**TO: PROSPECTIVE BIDDERS** **DECEMBER 10, 2021**

**RE: IFB-6711 – NEW CONSTRUCTION OF COMMUNITY SCHOOL 35**  
**ADDENDUM NO. 4 - CITY RESPONSE TO REQUESTS FOR INFORMATION AND CLARIFICATIONS**

**1 H304 4TH FLOOR HVAC PIPING PLAN**

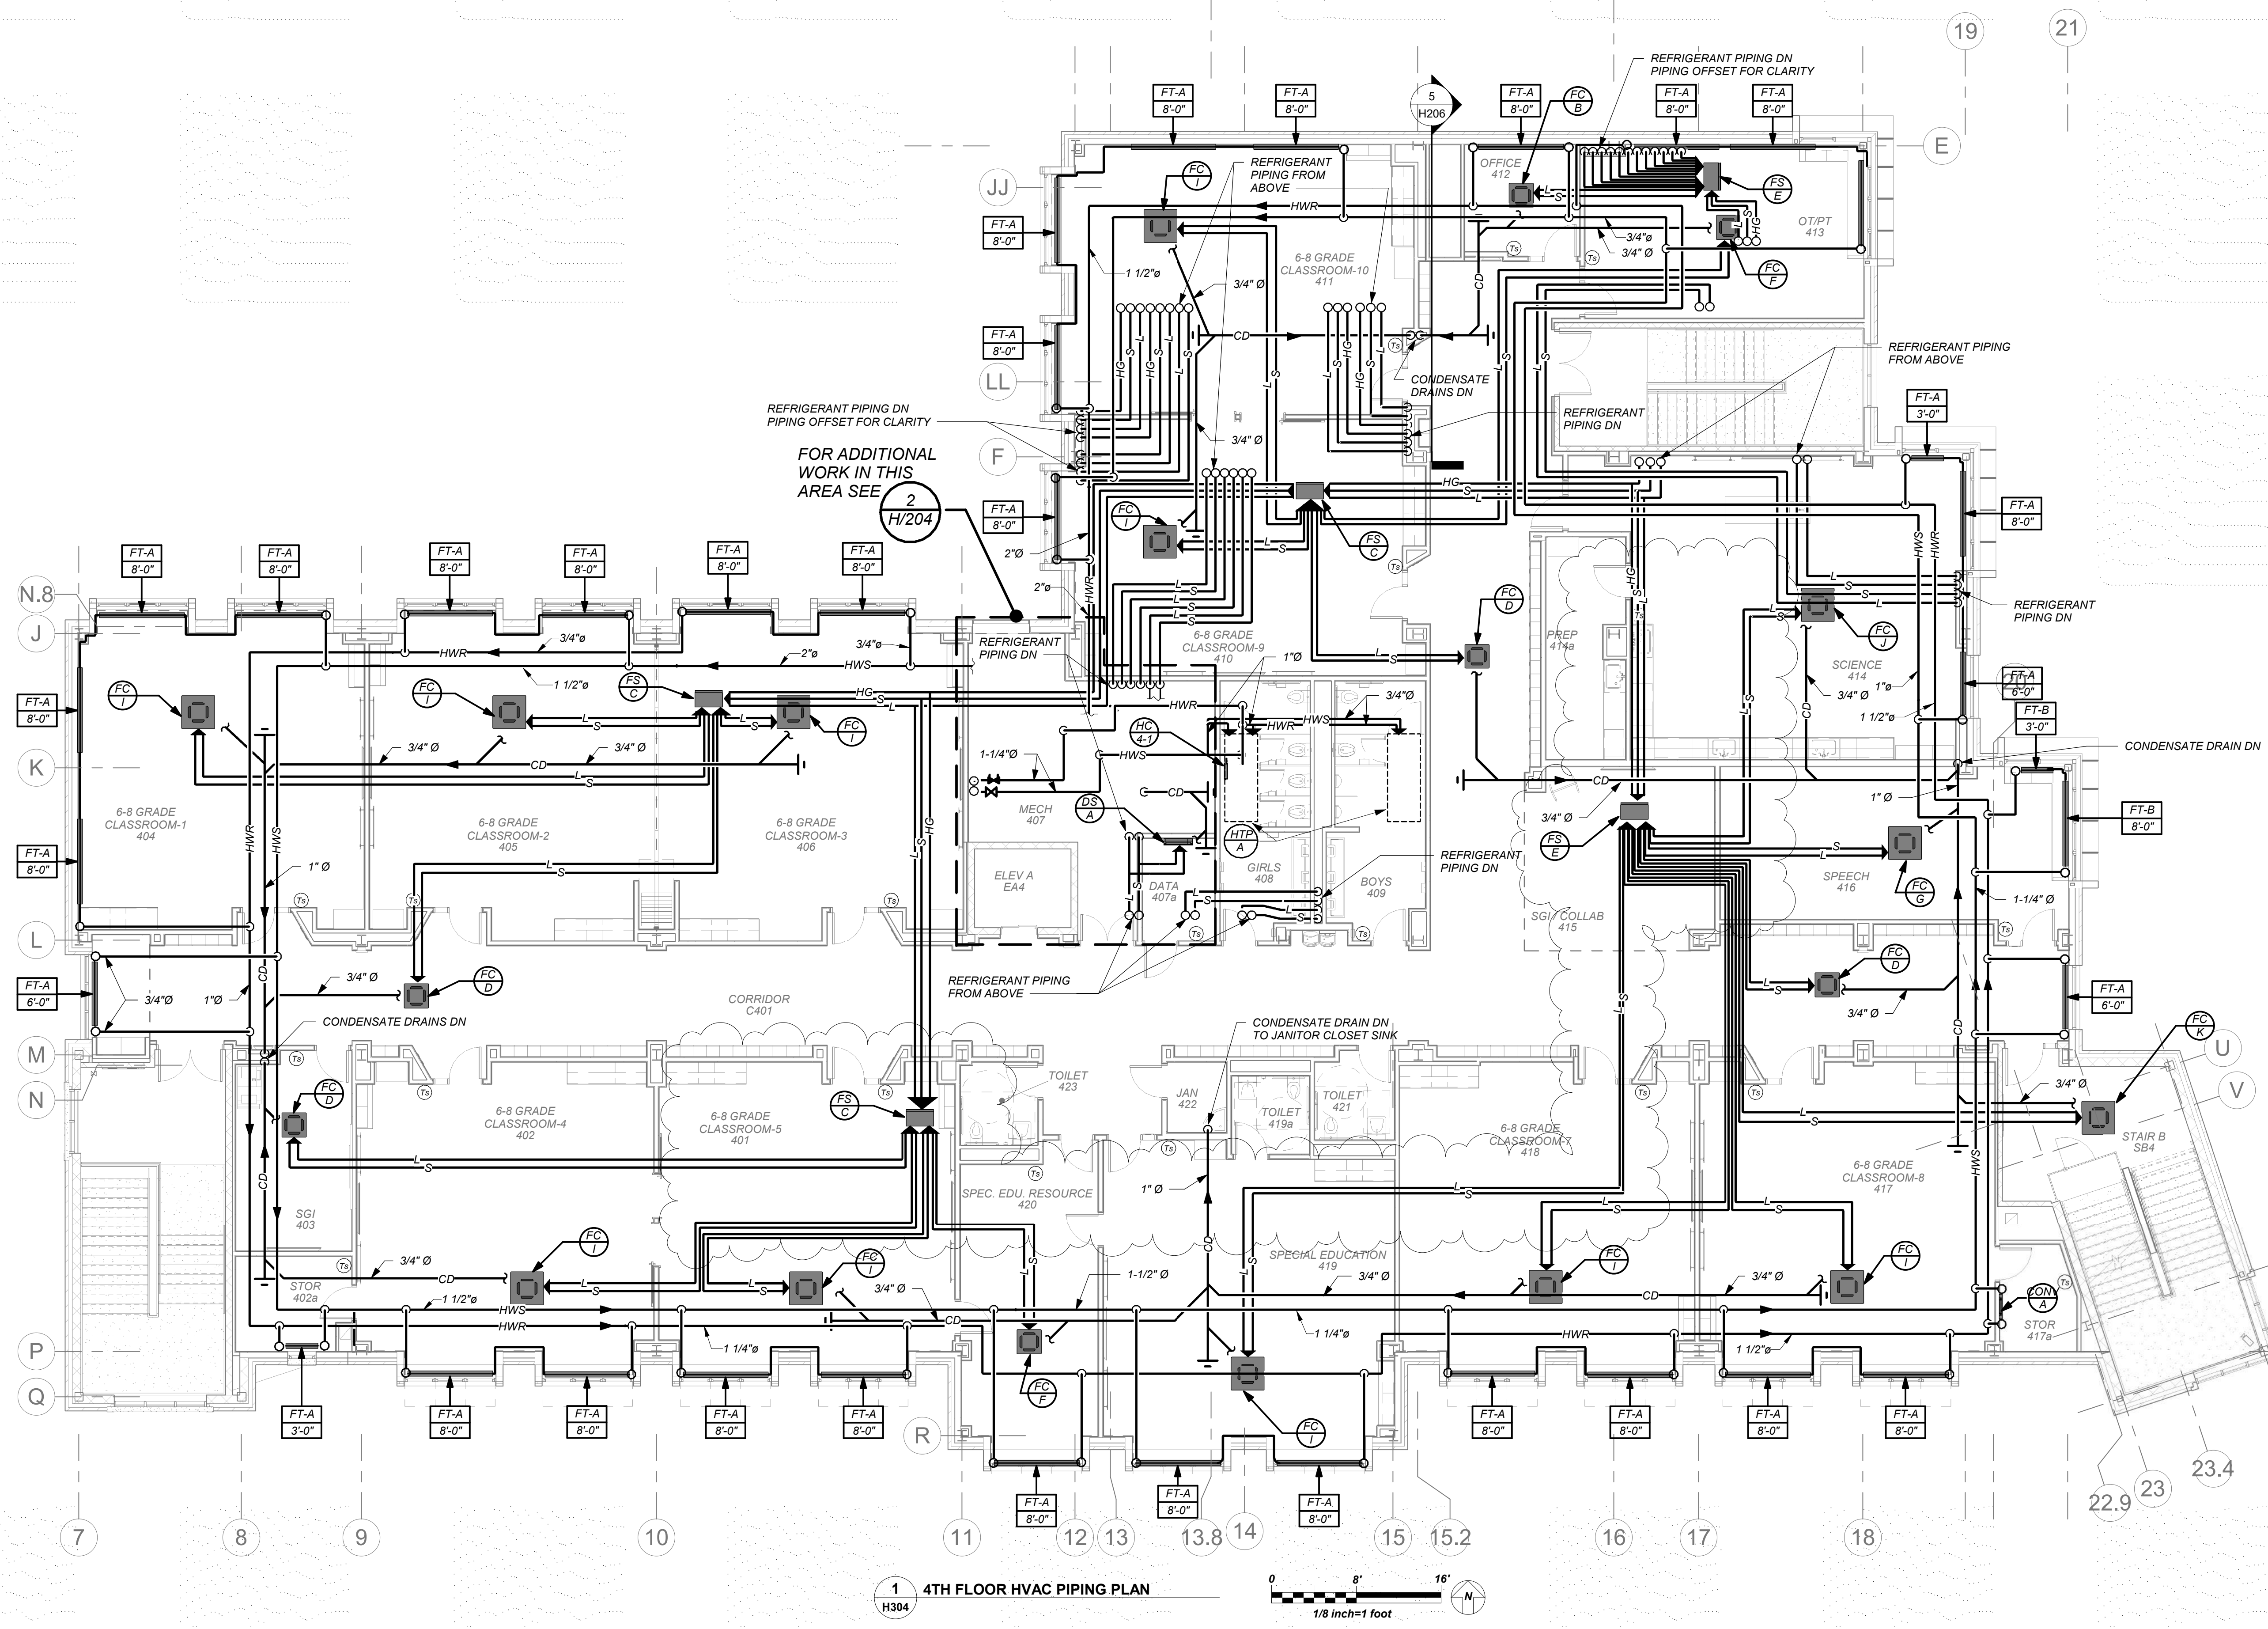
**9. DRAWING H304 – 4th FLOOR PIPING**

1. 4th Floor HVAC Piping Plan: Refrigerant piping revised. Refer to attached Drawing.
